JACKSONS ON GEORGE

Adaptive Reuse Study

for Lend Lease Development

October 2015

Roof Terrace - Level 2

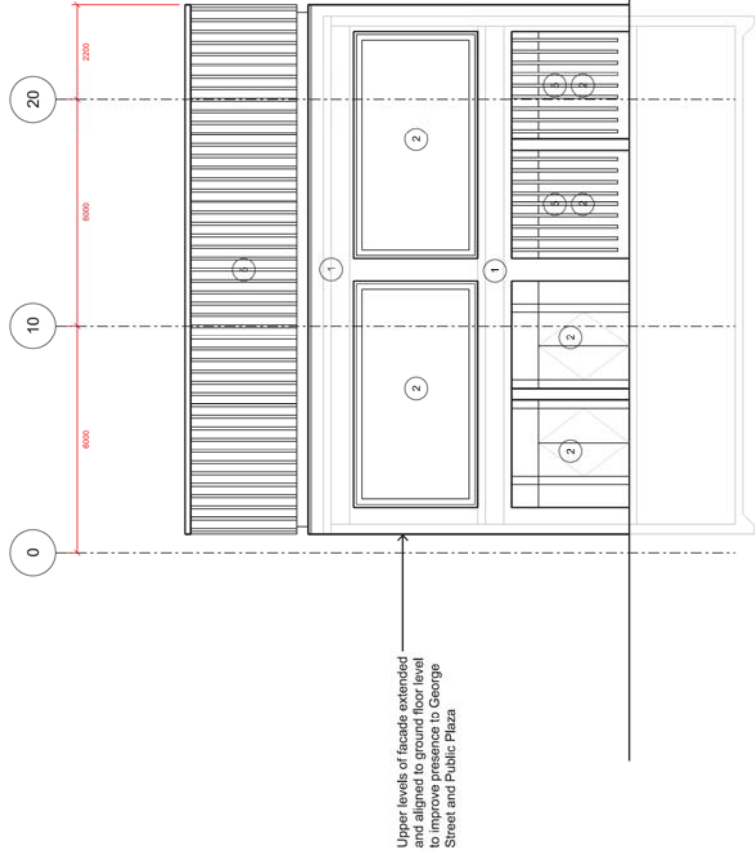
Removal of existing concrete roof is feasible. A demolition methodology that minimised stockpiling of demolition rubble on retained suspended structures will need to be developed to eliminate any need for temporary propping to the lower levels under construction loading. This is considered a feasible approach by TTW

Allowance for waterproofing and drainage to existing level 3 (now become an open deck) may increase the finish floor level. The proposed build up to the roof deck will be in light weight construction. Access to stairs will need to be considered in any future design development scheme.

The proposed roof top awning will be in light weight construction. This will have minimal impact to the existing concrete floor. Any transfer beam required could be accommodated within the new floor build up.

West George Street Elevation

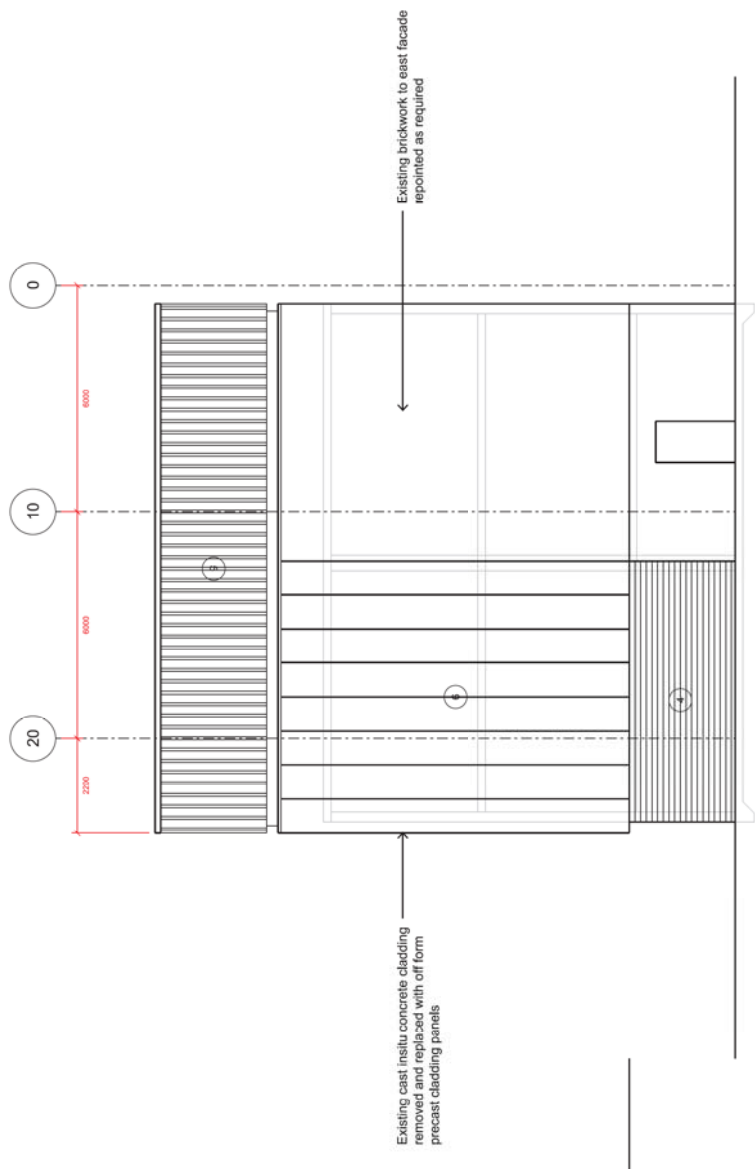
The existing non load bearing external masonry wall above level 2 can be demolished as contemplated under the Hassell indicative concepts. However, structural concrete upstands at level 2 on George St and south elevation will need to remain.
